**RE: Home 2 Suites Hotel
3021 University Blvd SE
Grading and Drainage Plan
Engineer's Stamp Date: 03/23/20
Hydrology File: M15D047**

Based upon the information provided in your submittal received 10/07/2021, the Grading & Drainage Plan **is not** approved for Building Permit, Grading Permit, and Foundation Permit. The following comments need to be addressed for approval of the above referenced project:

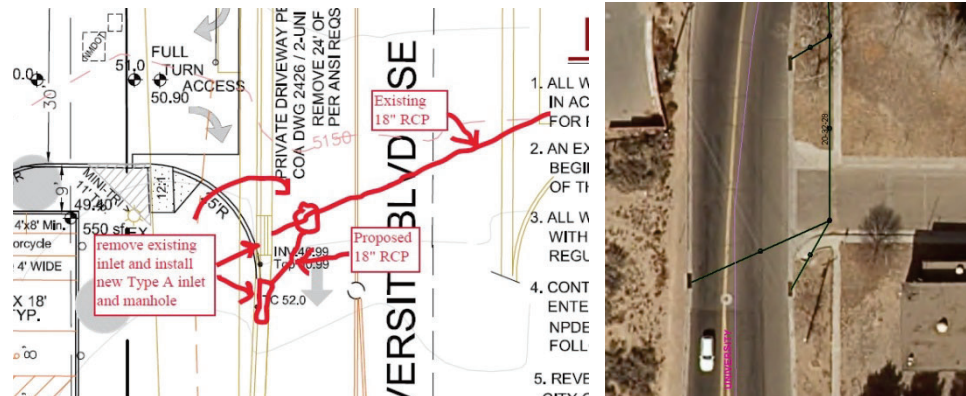
6. Please add these flowline points at each driveway to ensure that the required waterblock per CoA drawing 2426 is provided. See images below.

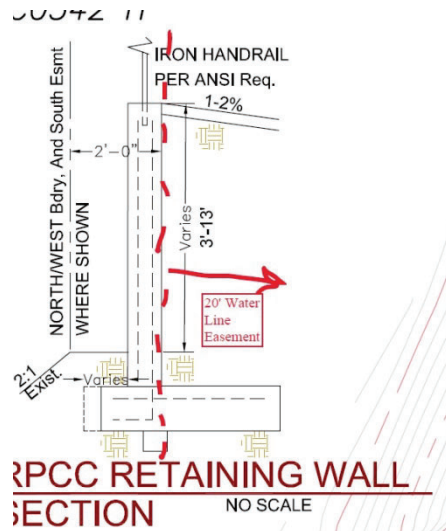
7. Please remove the existing inlet in the proposed drive on University Blvd and install a new inlet at the tangent of the curb return. Storm Maintenance does allow a bend in the storm pipe if it is within 5 feet of the proposed inlet. This may be the case. However if this cannot be achieved, than a new manhole will have to be installed on the existing 18" RCP as shown below. I have also attached some existing utilities within University Blvd that I could locate for your use. These may need to be shown. This inlet and maybe manhole will need to be added to the approved Infrastructure List. So this will have to be changed at the Development Review Board (DRB).
